February 8, 2016

**RE: Cripple Creek & Victor Mining, Co. Cresson Project M-1980-244;
Review Comments for Quality Assurance Monitoring & Test Results Final Report for Squaw Gulch
VLF Phase 1 (9,550 Bench to Completed Areas Outlined on Figure 2)-Additional Comments**

Photo 1 Existing Liner Anchor Trench Stakes

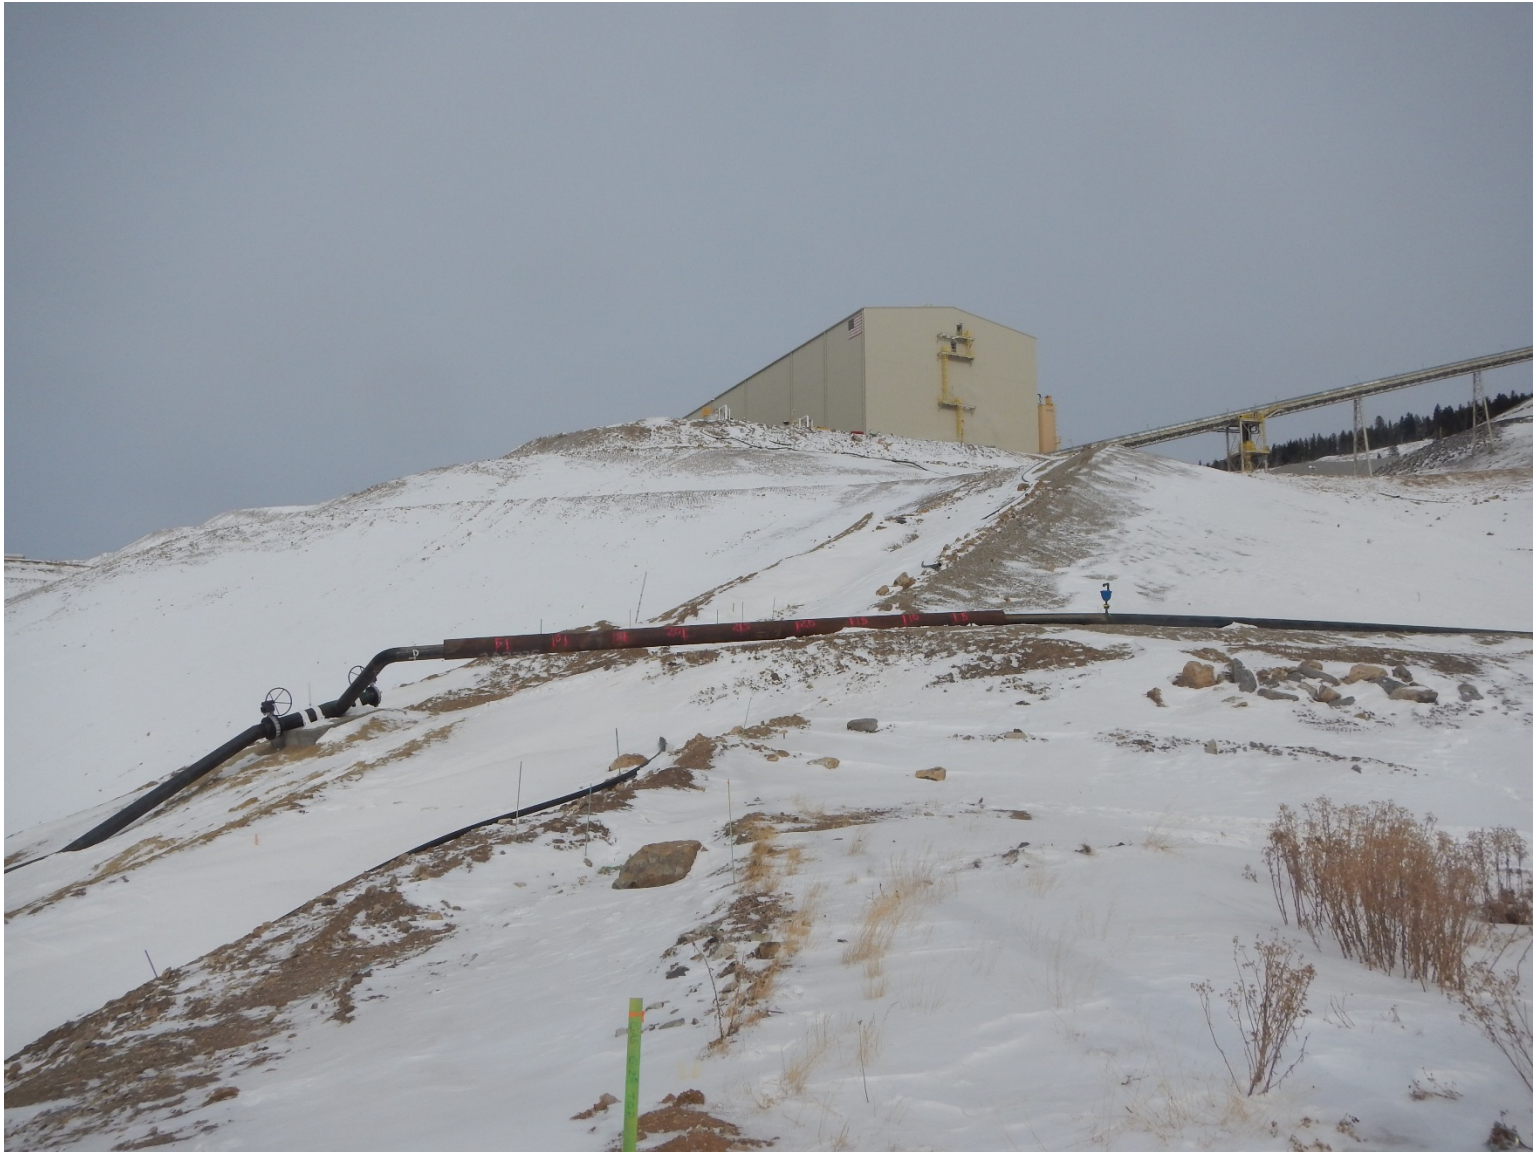
- a) TR-76 proposed a sleeve to be installed over the unlined portion of the 14-inch barren solution steel pipe alignment between the Mill Platform Drainline Containment Area and the Squaw Gulch VLF Liner Limit. The Division has verbally requested a ROC drawing demonstrating the required 10+ feet of overlap over the two liner limits. This ROC drawing must be stamped by the engineer of record.*

Foresight West Surveying surveyed both ends of the pipe sleeve and the sleeve is shown on ROC Drawing 8 of 8 attached with this letter. The geomembrane liner locations shown are approximately on the 2-foot bench next to the anchor trench and the survey points recorded at each seam. (See Issued for Construction Drawing A220 Section 1 for a section of the anchor trench). In addition, Amec Foster Wheeler measured and painted 5 foot increments on the pipe and photographed the area to further demonstrate the location relative to the liner. Photographs are attached with this letter.

7 OF 8

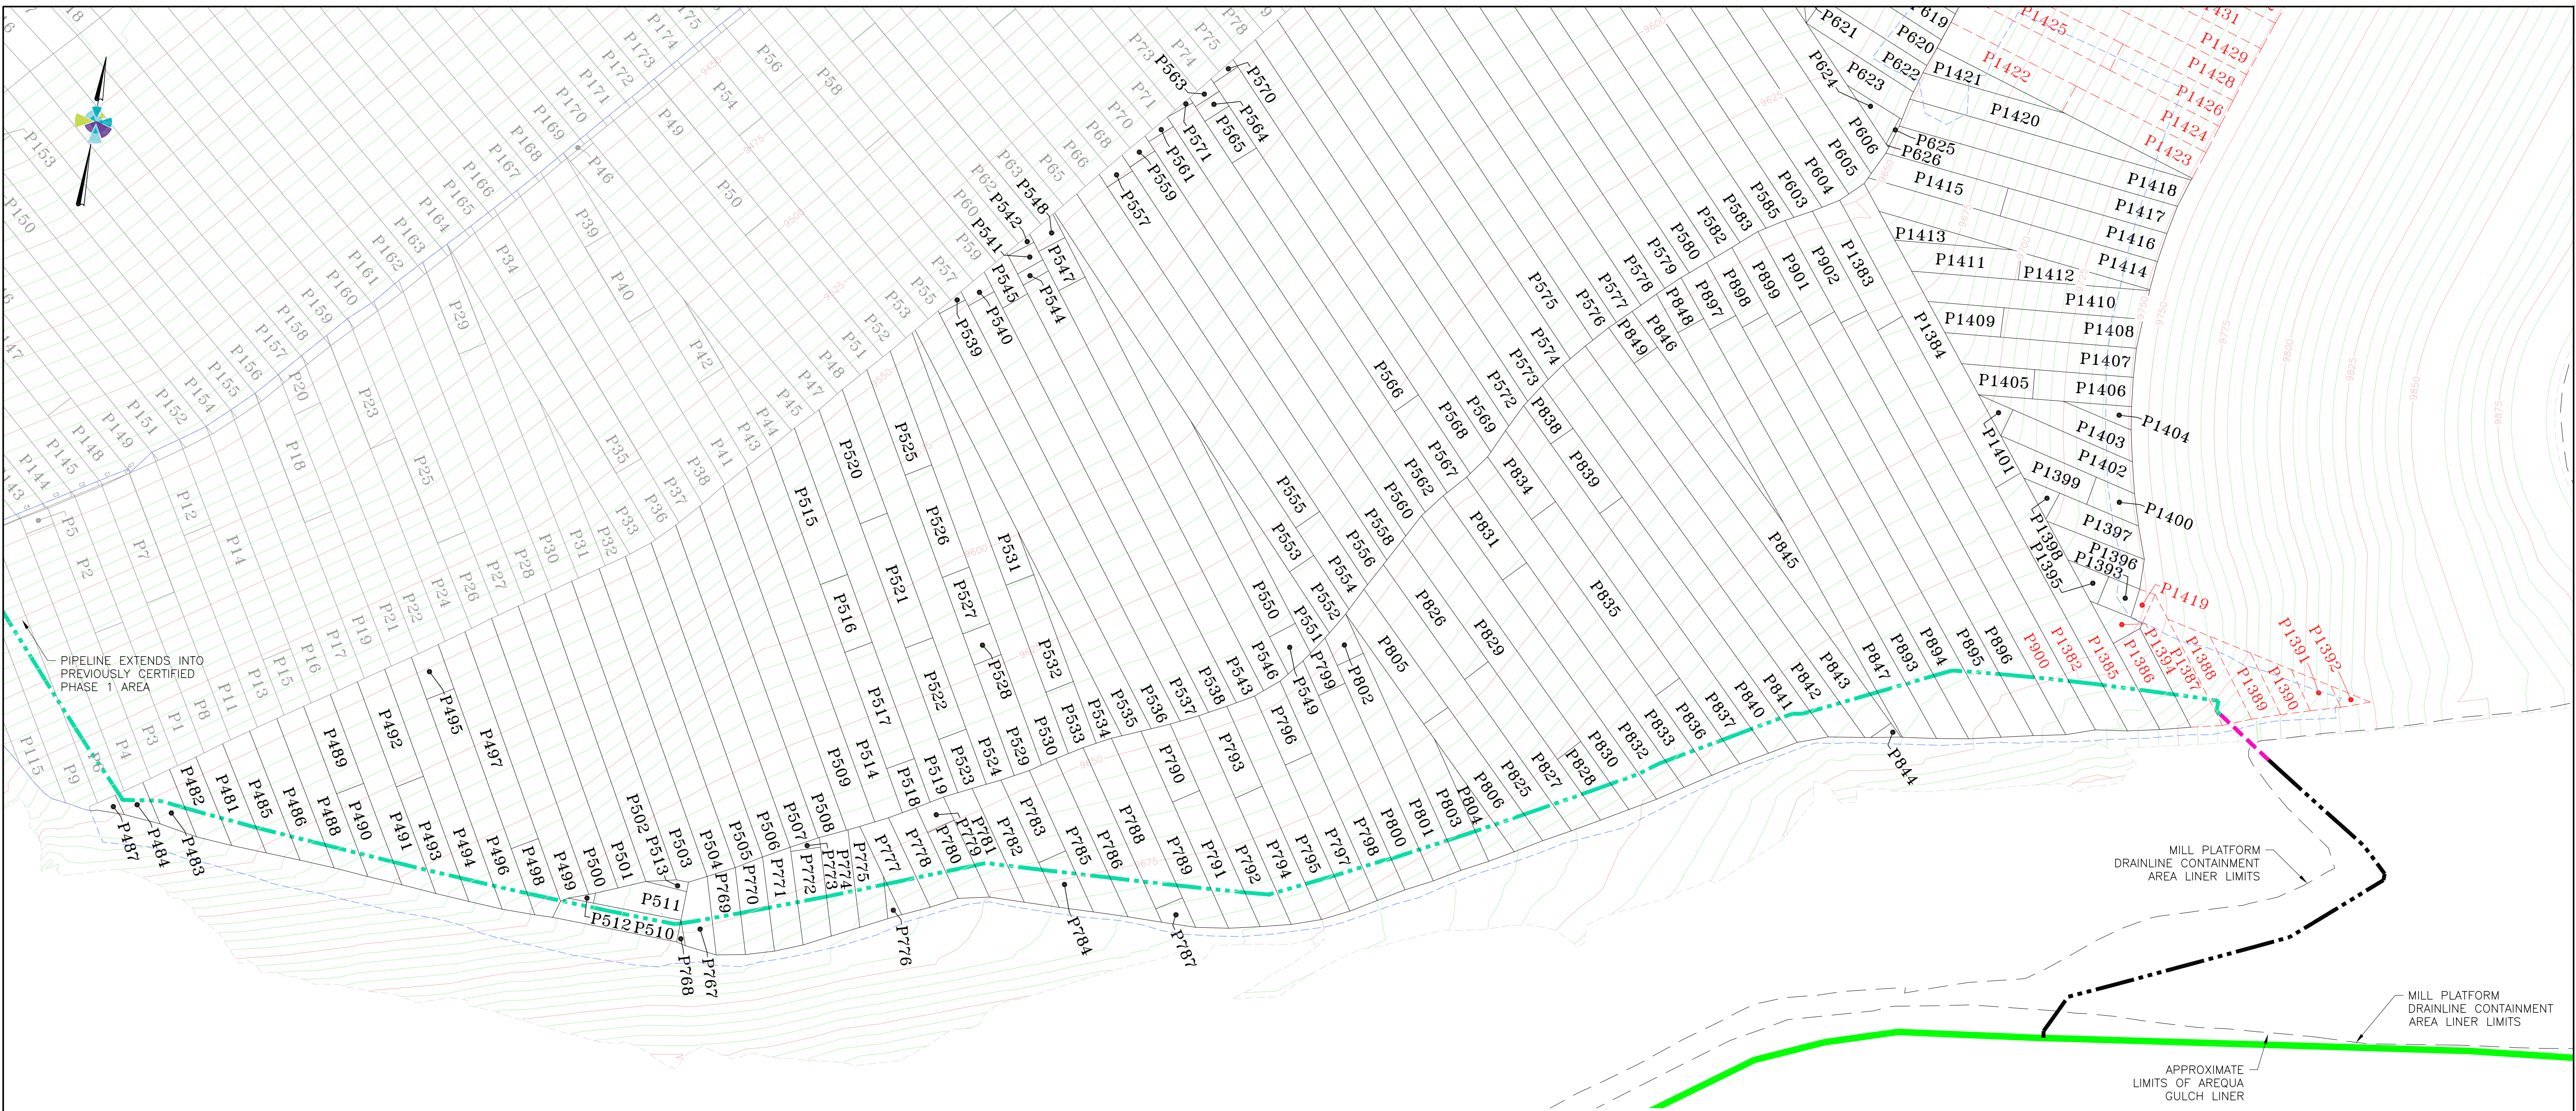
- b) The aforementioned "Barren Solution Pipeline D, As Constructed" received electronically on 2/1/2016 was not stamped by the engineer or record. Please provide a stamped version as a ROC drawing.*

- 4. The aforementioned "Barren Solution Pipeline D, As Constructed" drawing shows approximately 45 lineal feet of the pipe crossing geomembrane panels P1387 and P1388 which are not to be certified until some future date (according to both this drawing and ROC drawing 6 of 6). The Division understands from weekly construction reports and conversations with mine personnel that these two panels and the soil liner fill (SLF) below them meet specifications, but are not certified constructed at this time because the edge of these geomembrane panels must be left exposed to accommodate future construction. However pursuant to Rule 7.3.1 (f), this area must be certified as meeting the design plan prior to conveying designated chemicals. CC&V has verbally agreed to address this discrepancy with appropriate documentation to assure the Division and the record that the liner in the area of panels P1387 and P1388 meet the design plan.*

It was Amec Foster Wheeler's understanding that the state requested a figure to provide assistance with the review of the barren solution pipeline layout after it crossed onto the geomembrane liner, not a request for a signed Record of Construction drawing. The barren solution pipe downstream of geomembrane Panel P1386 has three sources of containment. The pipe itself, the geomembrane liner, and the clay liner (soil liner fill with a permeability of 1×10^{-6} cm/s). The submitted ROC report was signed and stamped by the engineer of record verifying that the facility was constructed in accordance with the approved design. However to satisfy the Divisions request, a stamped ROC drawing has been included with this letter. It is numbered ROC Drawing 7 of 8.

Amec Foster Wheeler did not include panels P1387 through P1392 or Panel P1419 in the record of construction report submitted January 2016. These panels were not included because the entire panel is not considered complete. The panels would have needed to be tied into a permanent anchor trench or be connected to another panel of geomembrane to be included in the ROC report. The above stated panels have edges that are placed in a temporary anchor trench. When construction continues, the temporary anchor trench will be removed and the small section of soil liner fill material below repaired to specifications and provide a continuous clay liner; in other words, geomembrane cannot be cut off and abandoned in-place in a temporary anchor trench. The purpose of a temporary anchor trench is to protect the soil liner fill below the geomembrane against weather, typically wind, rain, or snow as well as protect the geomembrane from any potential wind damage. These panels will be connected to geomembrane deployed in 2016. The geomembrane was accepted for drain cover fill (DCF) placement on October 26, 2015 and was also shown on the geomembrane acceptance map included with the weekly report week ending October 31, 2015. Drain cover material was placed over a majority of these panels, but an approximate 9-foot buffer was left to allow for the tie-in. Record Drawing 8 of 8 provides a detailed drawing of the area in question. Note 2 on the drawing states the shaded area of the panels meet the design plans and project specifications up to 12 feet from the temporary anchor trench, however, the entire panels will be certified in a future ROC report. The finalized data in the tables for the SLF nuclear density testing (in the vicinity of the temporary anchor trench) as well as the geomembrane tables will be reported when destructive and non-destructive testing; repairs; and deployment panel lengths are completed. It has also been noted on ROC drawing the path the barren solution is likely to take in the highly unlikely situation there is a leak in the pipe. As can be seen, the solution would remain on geomembrane liner.
